# PRODUCT UPDATE MEMO

### Bourns® CVH160808, CVH201205, CVH201610, and CVH252009 Series Multilayer Power Chip Inductors *Change to Country of Origin*

IC26150

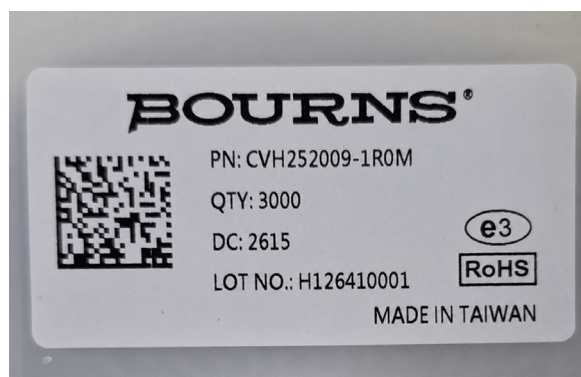
Existing Label

Revised Label

This update will impact only the COO reflected on new labels and shipping documents for the affected products.
